Re- Demolition works and construction of dwelling house,

31 Marine Parade Avalon Beach

DA2021/0981

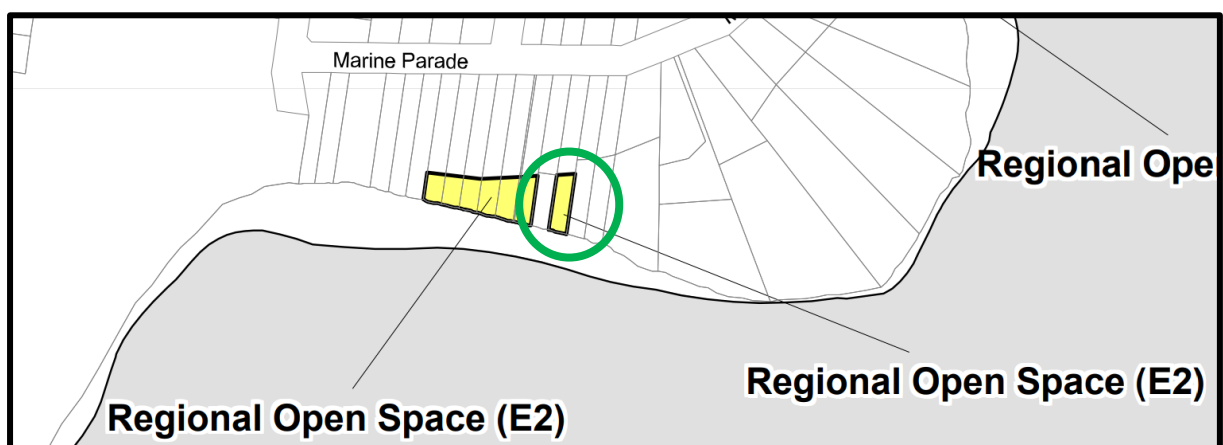
The proposal however, as evidenced in Drawing DA-001, Revision B and the submitted Statement of Environmental Effects (page 33) has calculated the landscaped area at 959.94 m² including the E2 Environmental Conservation zone area which is entirely contrary to the provisions of the DCP.

The available site area that can be considered as a basis to calculate site cover and the landscaped area is, by my estimate approximately 850 m², maximum.

The proposal, by virtue of this apparent breach of the site cover controls invokes the non-compliance provisions of *Tenacity* and requires a substantial reduction in the amount of built form proposed on the subject site which, it should be noted, can only be in the E4 Environmental Living zone.

The proposal requires significant amendments due to the magnitude of this non-compliance.
